Groundwater & Wastewater Services
Septic Project File & Data Review Worksheet

GWS File #: 7355B WASPS App #: 2758

IMPROVEMENT PERMIT for a RESIDENTIAL ON-SITE WASTEWATER TREATMENT & DISPOSAL SYSTEM

Permit #: **30002758** GWS File #: **7355B** Tax Parcel #: **001-023-13**

Sketch of Soil Evaluation Locations

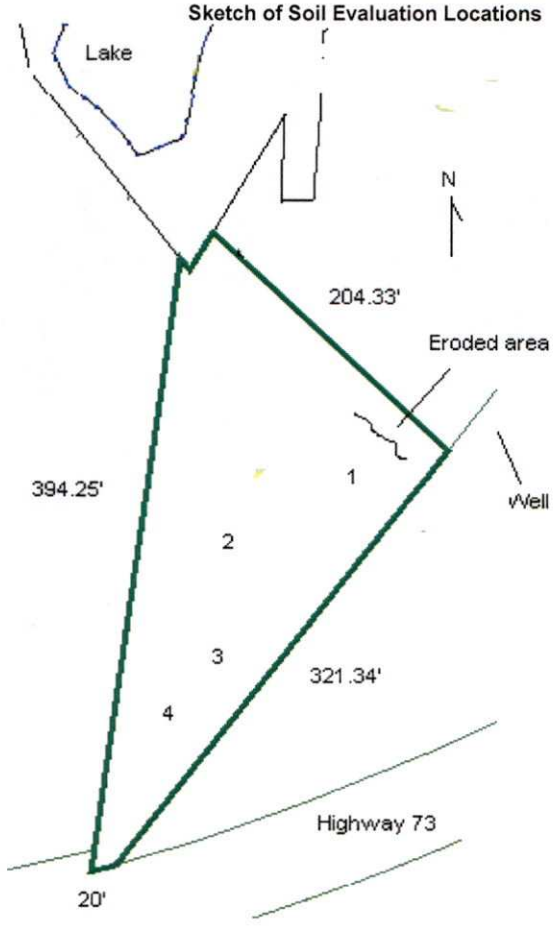
COMMENTS:
Does not appear to be 100% repair

FILE # 7355B
PERMIT # 2758
PARCEL # 001-023-13

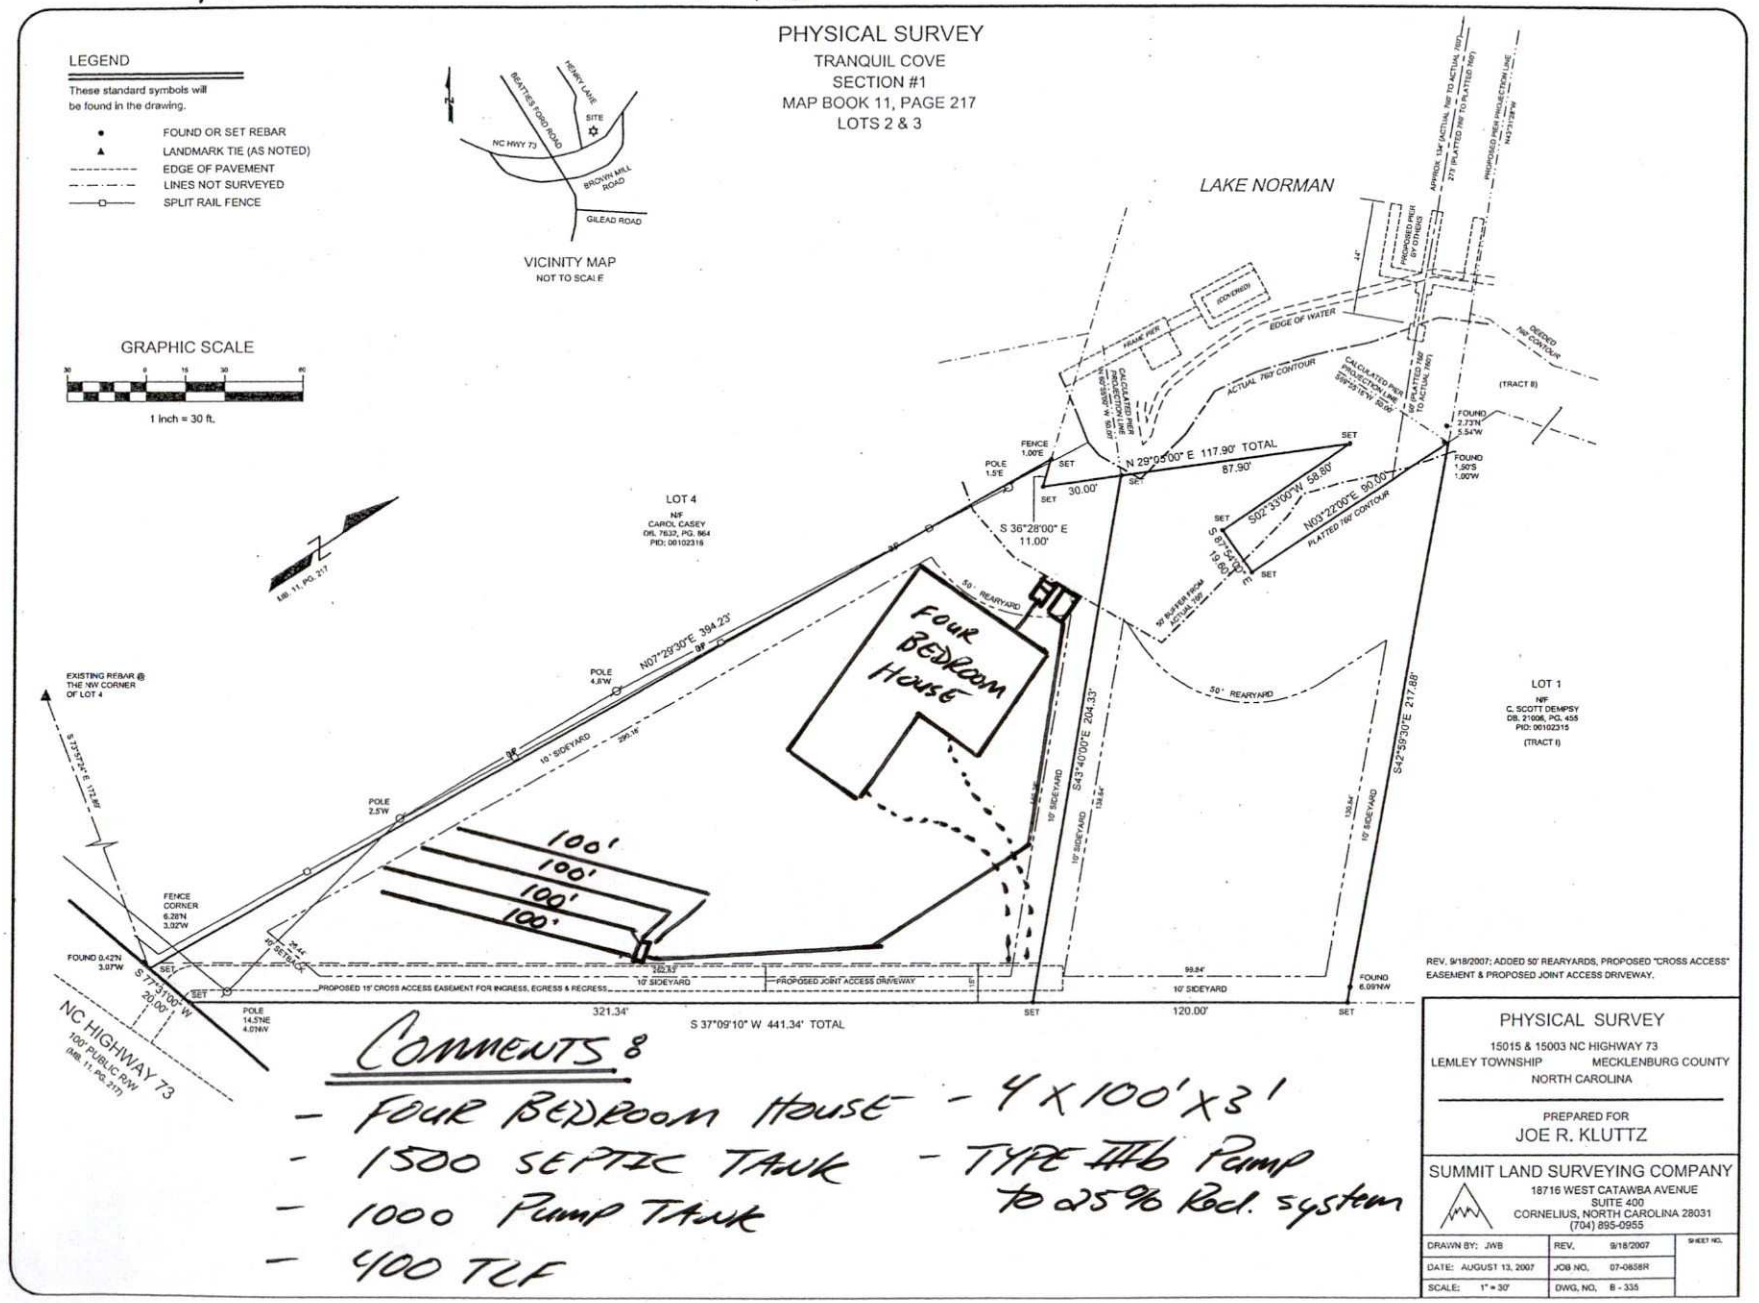
- Four Bedroom House - 4 x 100' x 3'
- 1500 Septic Tank - Type IIIb Pump to 25% Red. system
- 1000 Pump Tank
- 400 TLF
